June 6, 2022

**Subject:      Vernal Pools Water Budget Analysis for “The Sanctuary”  
Assessors Map 43, Lot 18, School Street, Manchester-By-The-Sea, MA**

As you know, I have been retained by Manchester Essex Conservation Trust, Inc. (“MECT”) to review “The Sanctuary” project (the “Project”) located off School Street (the “Property”) in Manchester-By-The-Sea.<sup>1</sup> Specifically, I have been asked to assess whether the Project as submitted to the Town protects both the northerly Vernal Pool (“VP”) and the southerly Vernal Pools (see Figure 1 on page 2).<sup>2</sup> My assessment is based on Project plans by Allen & Major Associates, Inc. (“A&M”), dated through May 5, 2022, as well as a related drainage report by the same firm dated through May 8, 2022.

Figure 2. Pre-development watershed for northerly VP.

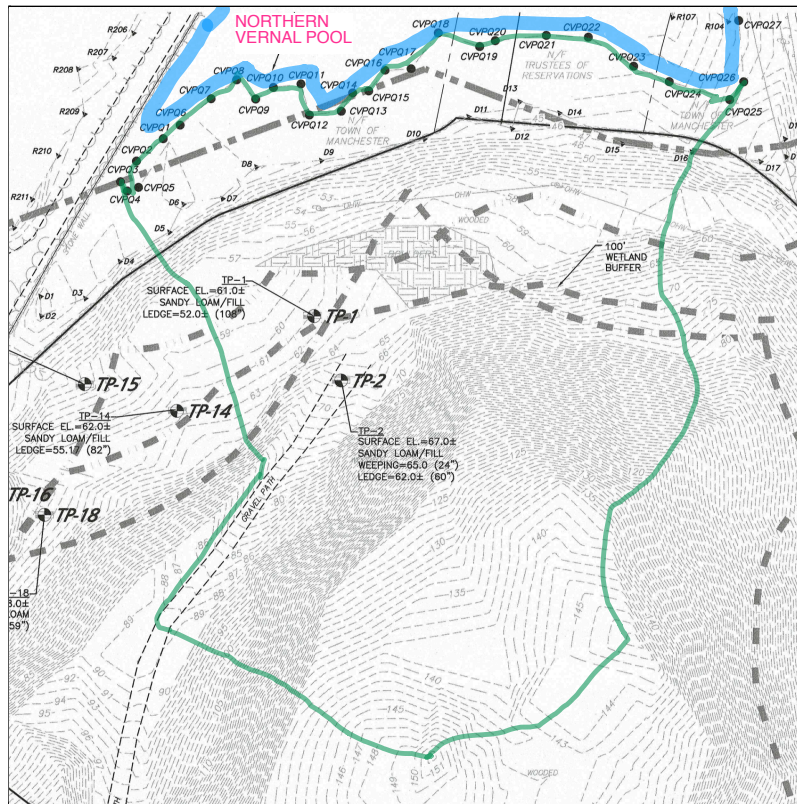
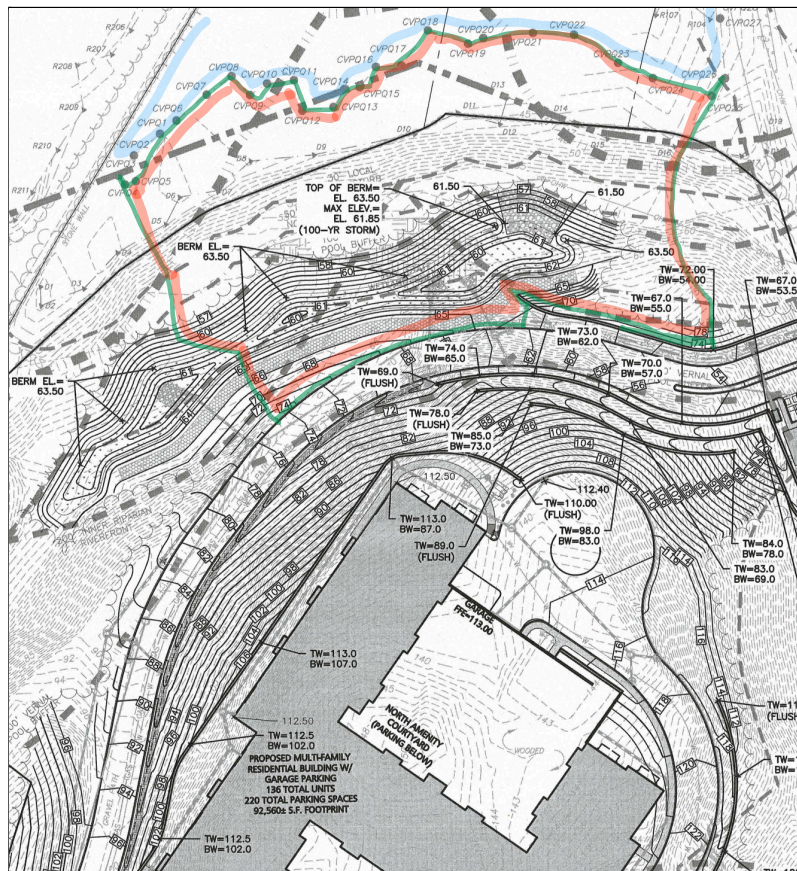
To calculate potential VP water budget changes, I first determined the *pre-development* project-related watershed area for both the northerly and southerly VPs (shown in Figures 2 and 4). I then calculated the *post-development* watershed area for each of the VPs (shown in Figures 3 and 5), and compared the two.

Regardless, groundwater flow is typically disrupted or redirected by site “improvements” such as roads, drainage infrastructure, subsurface infiltration, retaining walls and foundations. All of these disruptions occur on the Project site. In fact, up to 63% of the Project VP watersheds are substantially altered after development (see Figures 3 and 5, as well Tables 1 and 2 on pages 6 and 7).

Projected watershed changes to all VPs are significant. Alterations of as much as 65% occur. For instance,

- the watershed area for the northerly pool decreases by 63%;
- the watershed area for the southerly pool decreases by 27%.
- the velocity of stormwater entering the northerly pool decreases by 65%;
- the velocity of stormwater entering the southerly pool decreases by 24%;
- the volume of stormwater entering the northerly VP decreases by 63%;
- the volume of stormwater entering the southerly VP decreases by 27%;
- the times of concentration (Tc)<sup>12</sup> for the northerly pool decreases by 46%; and
- the times of concentration (Tc) for the southerly pool decreases by 24%.

Compounding the impacts, the flow length (that is, the total distance stormwater flows from one end to another through a watershed) is reduced both north and south after development. For instance, the existing flow length for the northerly VP is 450 feet; under proposed conditions that length is decreased to 140 feet. This 69% *decrease* in length is a significant change that would, when combined with a shortened Tc, potentially increase the impact of frequent, low-intensity storm events. Similarly, the existing flow length for the southerly VP is 190 feet; under proposed conditions that length is decreased to 145 feet, which represents a 24% *decrease* in length.

To maintain the fragile habitat characteristic of a vernal pool, a site designer normally strives to ensure that the annual water budget post-development, including proposed runoff characteristics, is in balance with pre-development conditions. In the case of this Project, there appears to be no attempt to mimic pre-development hydrologic characteristics for the VPs on or near the site.
